Australian Air Publication **721.79**

VAMPIRE MODIFICATIONS

(Nos 101 to 200)

(b) Drawing A.12142, Sheet 1, after Part Nos. in Table for Tank Bay No.1 as follows:-

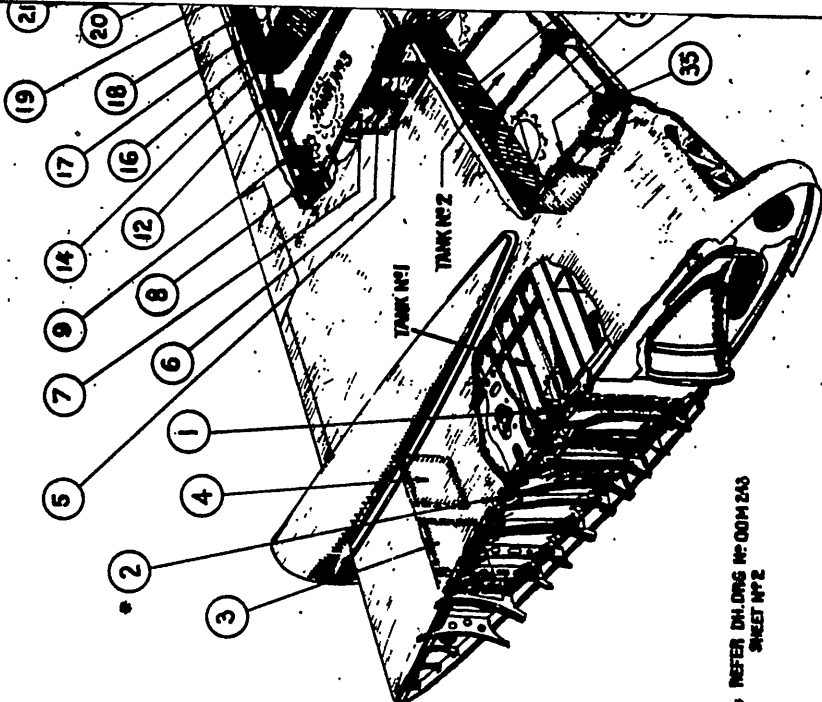
- (i) Insert "OOD1461ND" in lieu of "D007721ND".
- (ii) Insert "OOD1459ND" in lieu of "D007719ND".
- (iii) Insert "OOD1462ND" in lieu of "D007722ND".
- (iv) Insert "OOD1460ND" in lieu of "D007720ND".

(c) Drawing A.12143, Sheet 1, at the lower right hand corner -

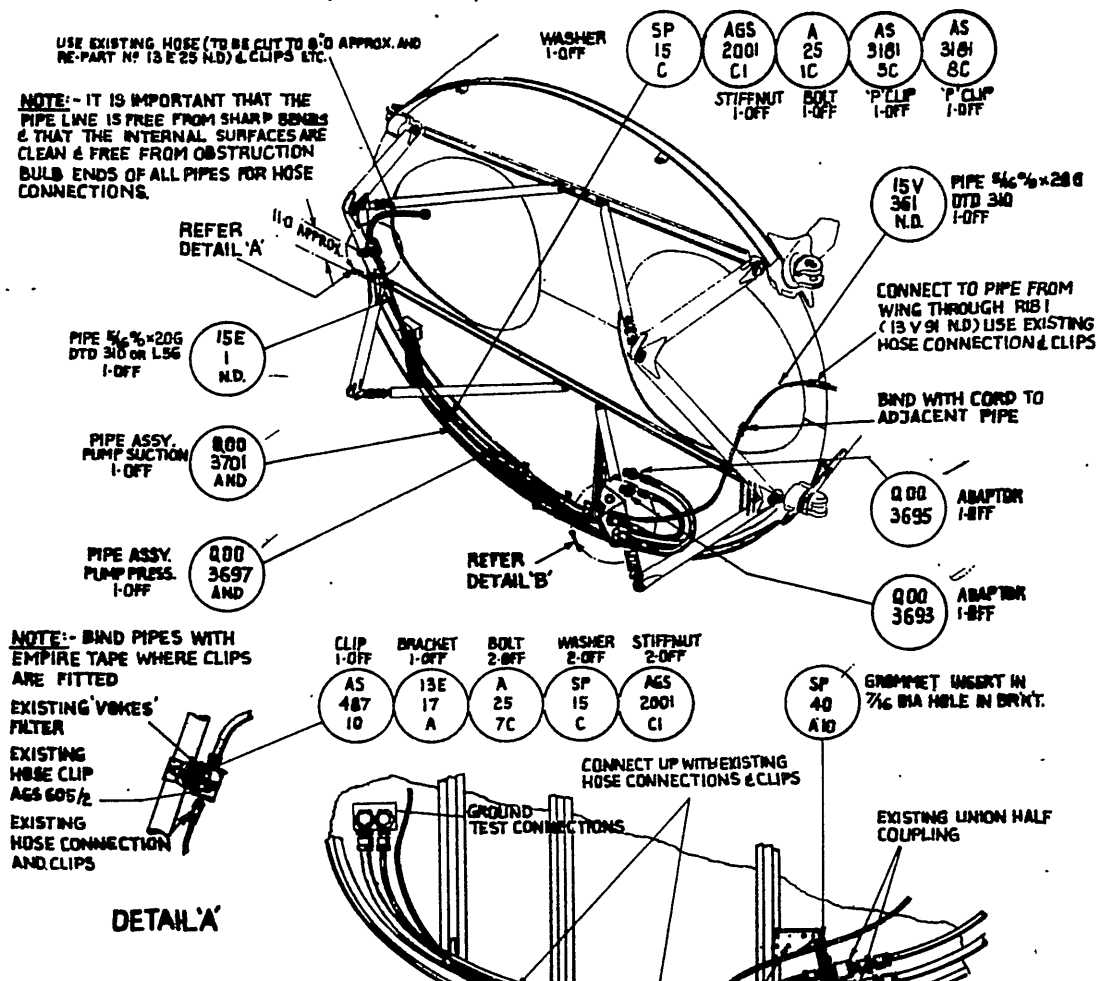
(1) Insert "A25/1B, Bolt 8 off" in lieu of "A25/2B, Bolt, 8 off".
